Water Treatment & Transmission Improvements Program  
Draft Environmental Impact Report

## 2.11 Adam Henderson

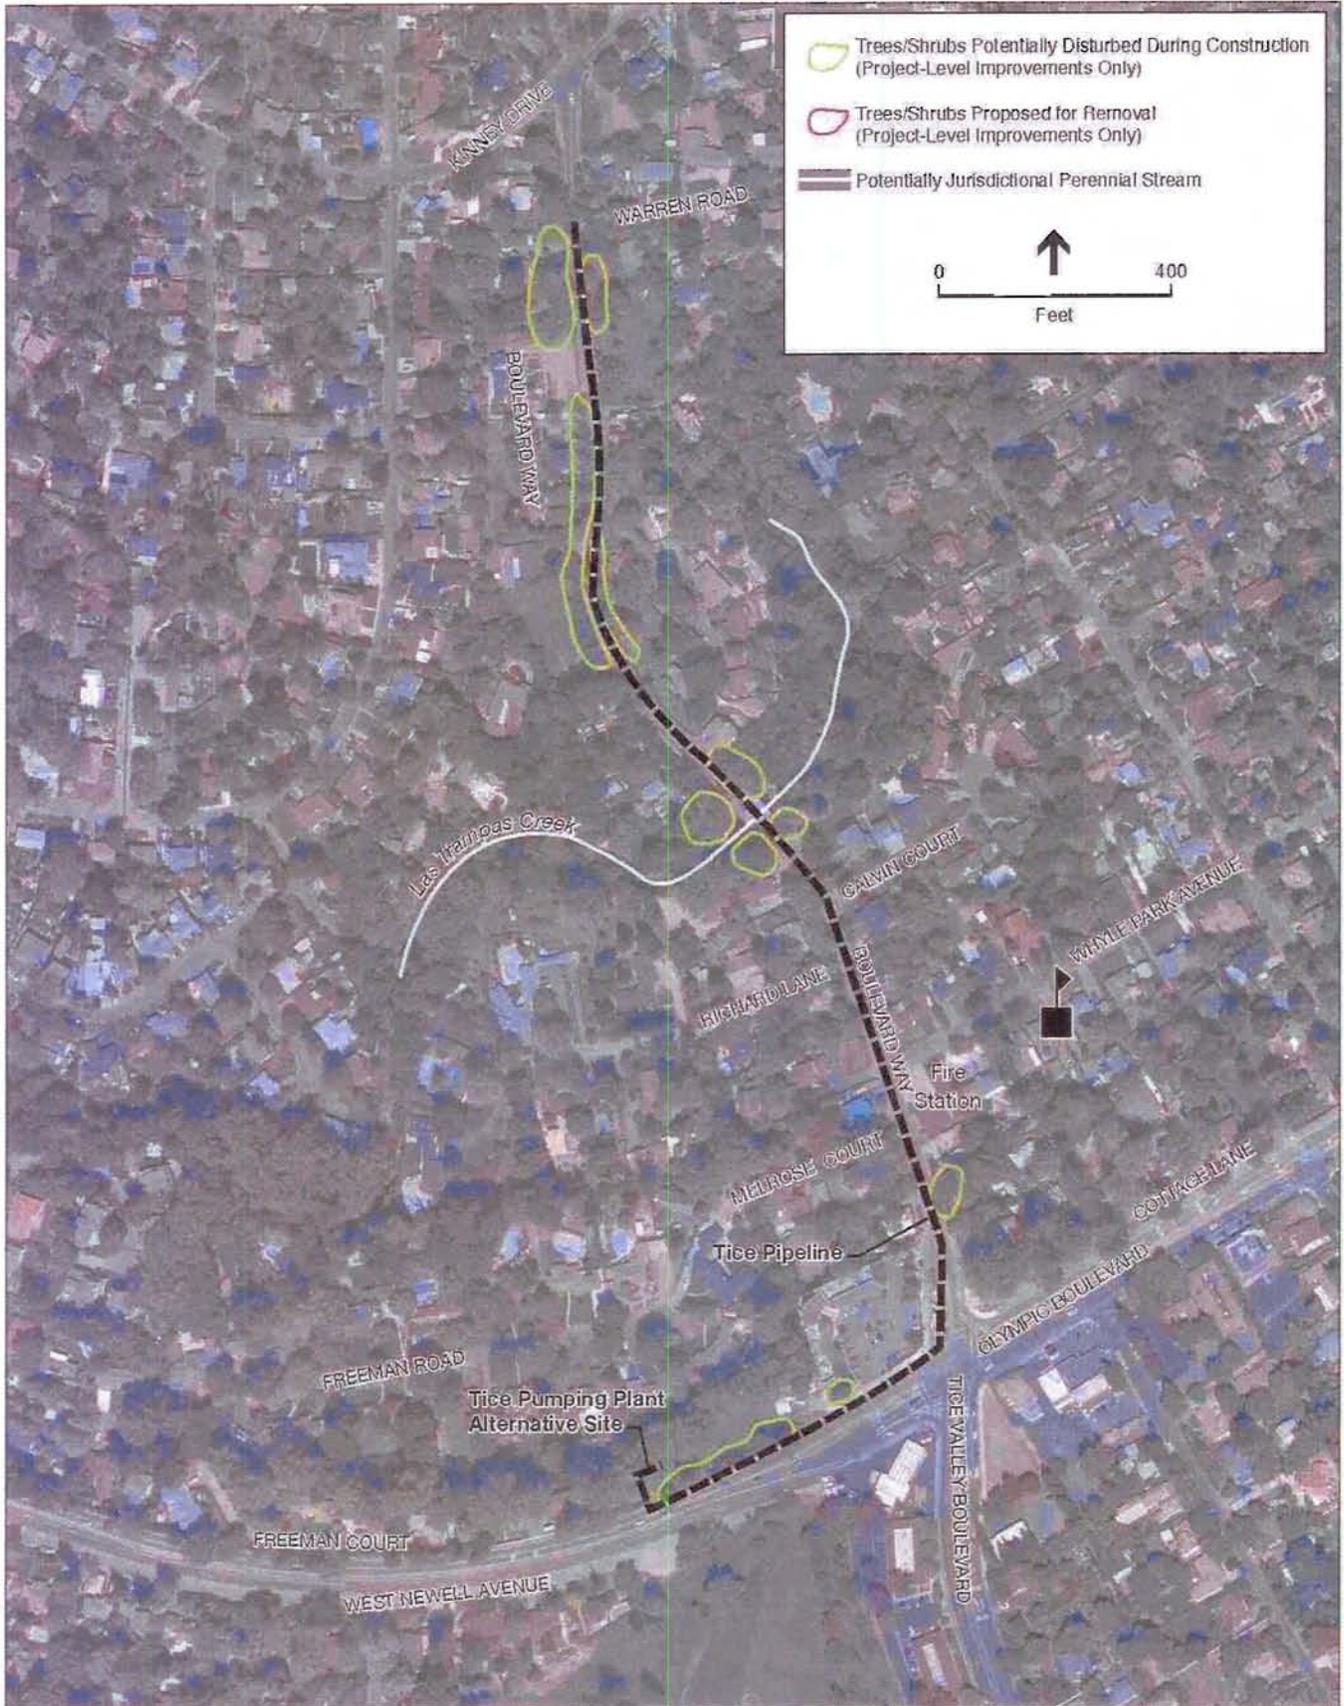
I am building a home at 300 King Drive, which I hope to move into by the end of the year. My property runs from King Drive down to the cul-de-sac at the end of Olympic Drive frontage road.

I was not aware that the proposed pumping plant would receive water from the existing line on Boulevard Way and then pump water back across Olympic Blvd back to Boulevard Way. I am opposed to the placement of the plant at the end of the cul-de-sac, as it will change the character of the neighborhood. Presently the area is residential and the construction of the plant will require the removal of the trees and the installation of a high retaining wall behind the plant. From the Olympic Drive frontage road you will immediately see the pumping plant and then the gas station. This will change the feeling of the immediate neighborhood from residential more like a commercial area.

The alternative plan that developed by your staff, near the existing commercial shopping area is a much better location as there will be no need for massive excavation and the removal of numerous trees. Instead the new plant could be constructed back from the road and would not be noticeable. In addition Olympic Blvd. would not need to be torn up for the construction of the pipes going back and forth across the street.

I am enclosing a portion of your report that pertains to the Tice Valley Pumping plant for your review. I have highlighted areas of the report I feel show the alternative site to be a better choice for the location of the pumping plant..
